**RE: R1613/1614 CT HVAC and Water Heater Process and Impact Evaluation Report
and CT Heat Pump Water Heater Impact Evaluation Report**

Eversource Energy (“Eversource”) is pleased to submit these written comments regarding the draft evaluation report: *R1613/1614 CT HVAC and Water Heater Process and Impact Evaluation Report and CT Heat Pump Water Heater Impact Evaluation Report*, Review Draft (“Draft Report”), submitted December 22, 2017 by West Hill Energy and Computing, Inc. (“Evaluator”). Eversource received the Draft Report on January 4, 2018 with a request to provide comments by January 18, 2018. Per the Energy Efficiency Board Evaluation Road Map Process, these comments are for consideration for inclusion in the Final Report.

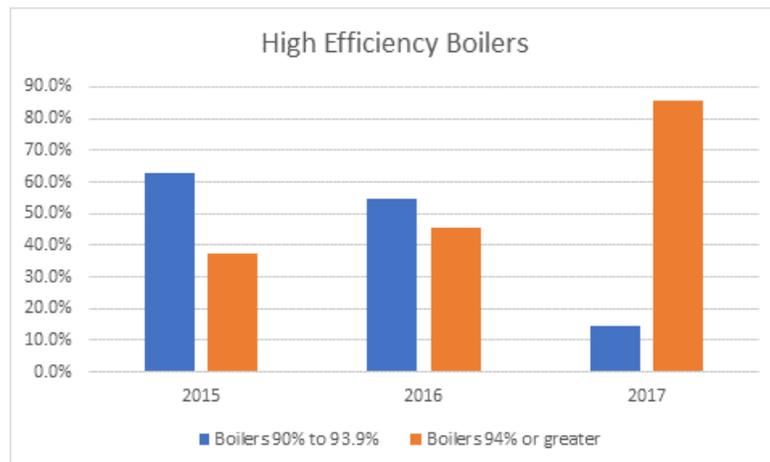
- In 2015 and 2016—the years evaluated for this study—the boiler rebate was \$750 for all units with efficiencies of 90% or greater. In 2017, a tiered rebate was instituted that gave a \$450 incentive for 90% to 93.9% boilers, or \$750 for boilers with efficiencies of 94% or greater. When this change was made, the percent of boilers of 94% or greater doubled. The figure below shows the impact of the tiered incentive in driving customers to higher levels of efficiency.

These data are at odds with the free-ridership results from the study, and show that although there may be “partial” free-riders at one efficiency level—such as 90% efficiency boilers—the program’s use of tiered incentives can cause such customers to adopt higher levels of efficiency, resulting in savings that are attributable to the program. The final report could provide additional insight on this issue if it can explain how NTG ratios might be different in 2017 given the current boiler incentive tiers.
